Danfoss

May 2021 | Danfoss Climate Solutions for cooling

TECH
INSIDER

Operating envelope:

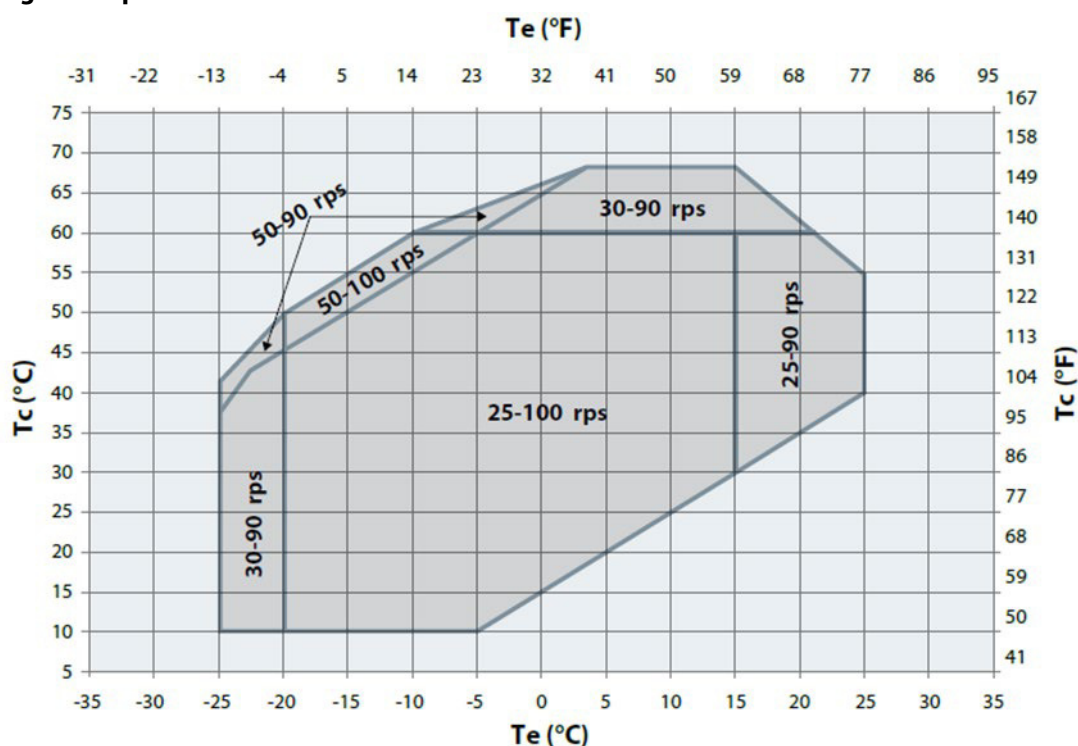
For detailed capacities, please refer to Coolselector2. Polynomial coefficients are also available directly in Coolselector2. For further information, please refer to application guideline.

The VZH088/117 code G new models with R410A/R452B/R454B were released in March 2021.

AKV 10P8 Single pack version
Imperial [Inch] connections: Code no. 068F5217

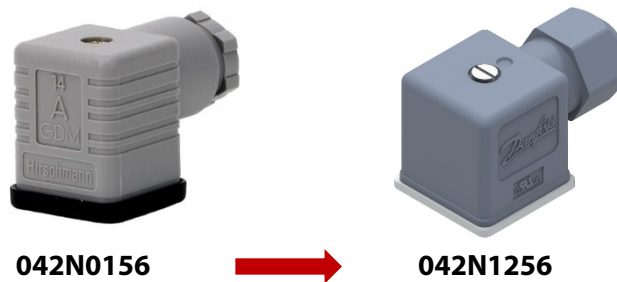
We are very pleased to announce the extended AKVP valve range to include sizes AKV 10P8 direct operated valve and AKV 10PS8 servo designed valve to meet the increasing market demands of higher evaporator cooling capacities. Both versions come with either imperial or metric connections that are available in single format.

To facilitate conversion from other AKVP valve sizes and capacities, we have included the AKV 10P8 orifice and AKV 10PS8 piston in existing AKVP service kits.
